Appendix 5 – Material Deviations from Permitted Plans

MEENBOG WINDFARM

Ecological Assessment of Planning Deviations

Prepared for: **Donegal County Council**
Client Ref: Ud20254 DCC:017800000216

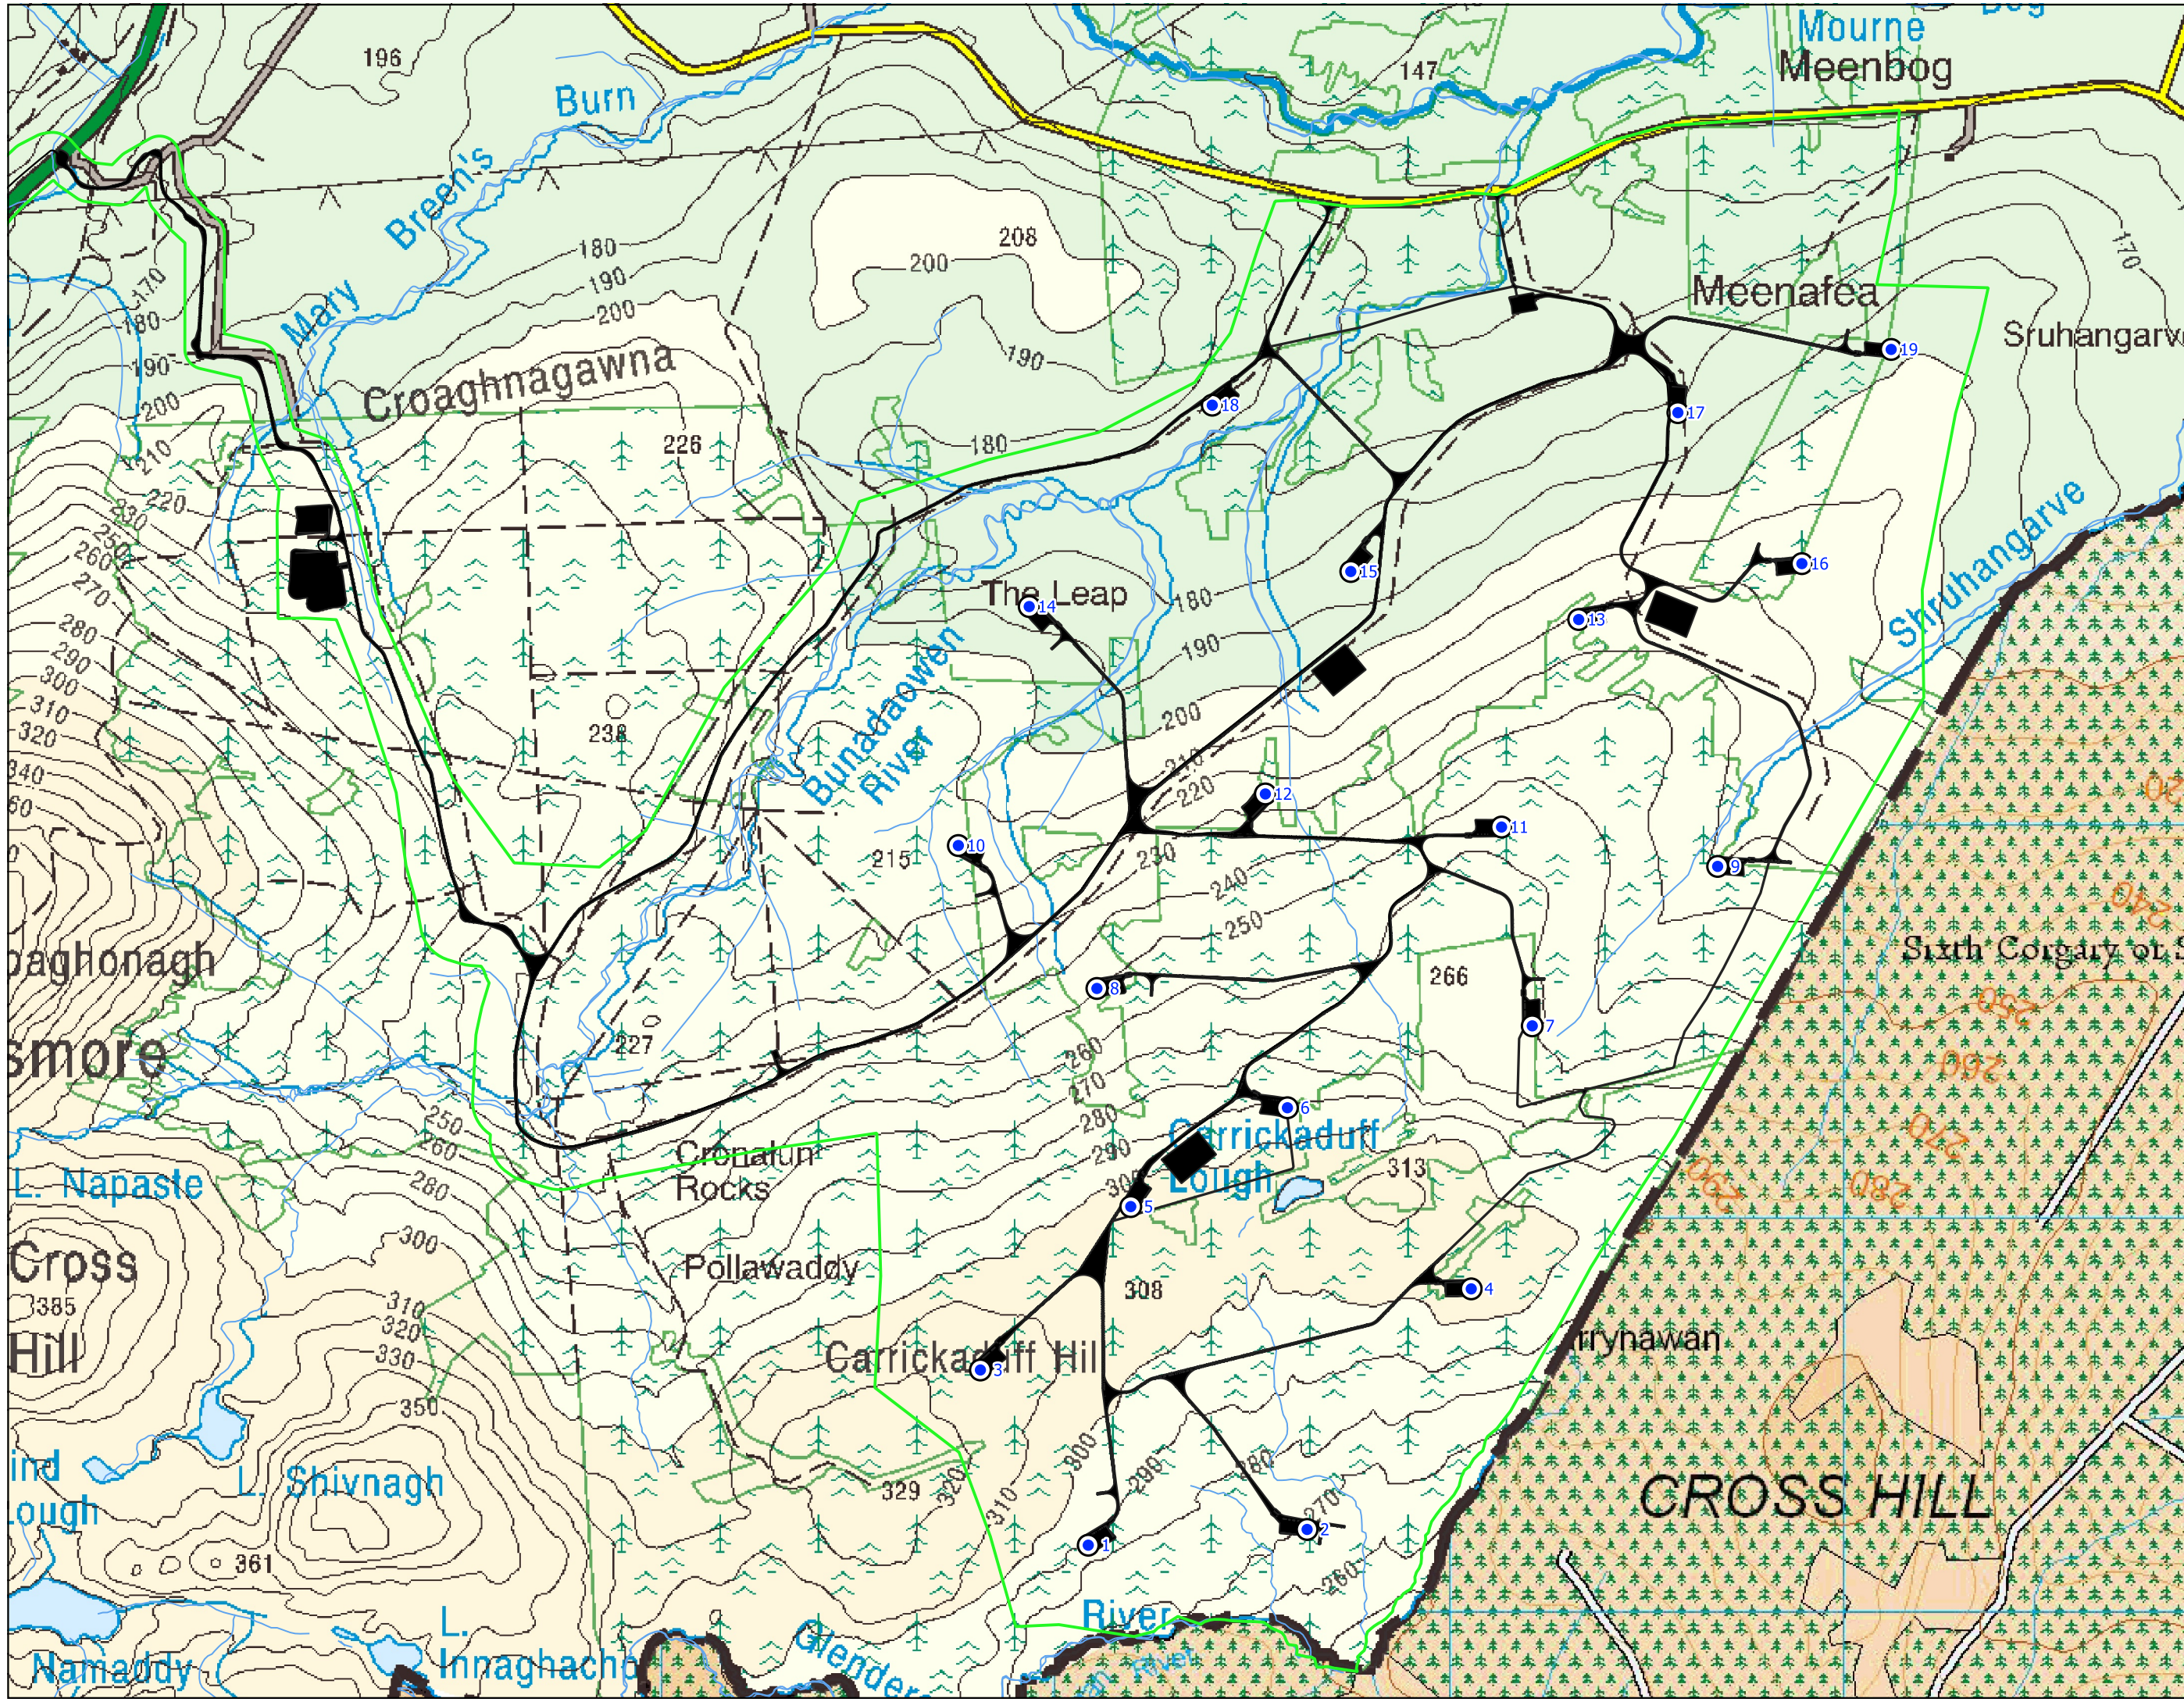
However, as the 16 no. deviations posing a higher ecological risk were not appropriately considered within the scope of the original EIAR / AA, and the submitted opinion on the AA Screening report does not provide sufficient information upon which the planning authority can reach a screening conclusion of no 'likely significant effects', then the remaining route is an application to An Bord Pleanála for 'substitute consent' under Part XA of the Planning and Development Act 2000 (as amended). This is in two stages firstly an application for leave to apply for substitute consent and secondly the application for substitute consent. This would involve the preparation of a remedial Natura impact statement and/or a remedial environmental impact assessment report.
